**PRRWF20250002**

**Wesley Homes Bradley Park PH2 – Retaining Wall  
(PERMIT APP# PRRWF20250002)**

**PERMIT REVIEW CORRECTION LETTER – dated January 31, 2025**

Project: Wesley Bradley Park Phase II, AHBL No. 2220236.20  
Subject: Response to Comments dated January 31, 2025

<p>2215 North 30th Street Suite 300 Tacoma, WA 98403 253.383.2422 TEL 253.383.2872 FAX</p>	<b>WESLEY BRADLEY PARK - PHASE 2</b>		<b>EXHIBIT J</b>
	<b>CARE CENTER REVISION - STRUCTURAL CONCEPT AT GRID 3</b>		
	DRAWN BY: KRG	DATE: 09/12/2024

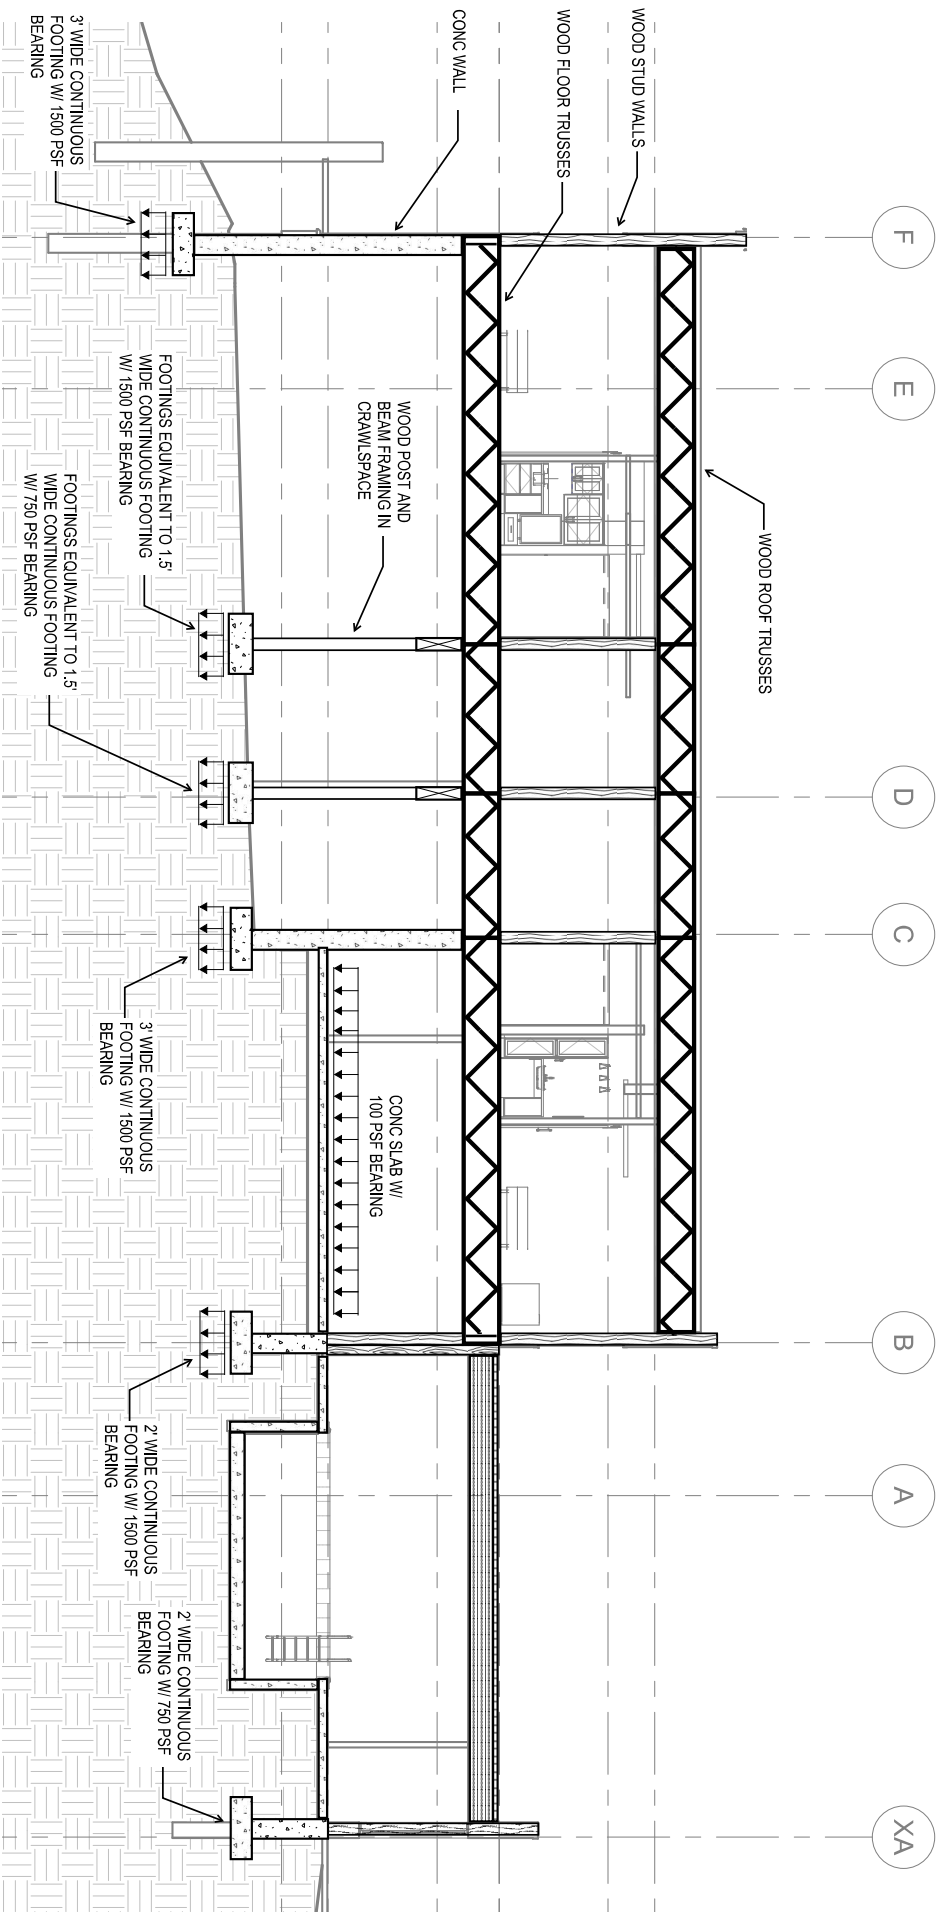
1. Footings will be on the northern portion lot. Per the geo report this portion of the lot has significant organic fill that overlays the native soil. Review soils report and revise details as necessary. Geo engineer provide a path of either pipe piles or ground improvements. Detail the path that will be used on the plans.

**Response: Refer to updated plan for note to remove and replace the existing fill soils with structural fill per the geotechnical report.**

Results of the supplemental stability analysis indicates that pile supported foundations would no longer be required with the revised design. SLIDE2 output graphics of the cross section showing the failure surfaces with the minimum safety factor along with soil parameters used in the analysis are attached. Code required minimum safety factors of 1.5 under static conditions and 1.2 under seismic loading (pseudostatic conditions) are met with the revised design.
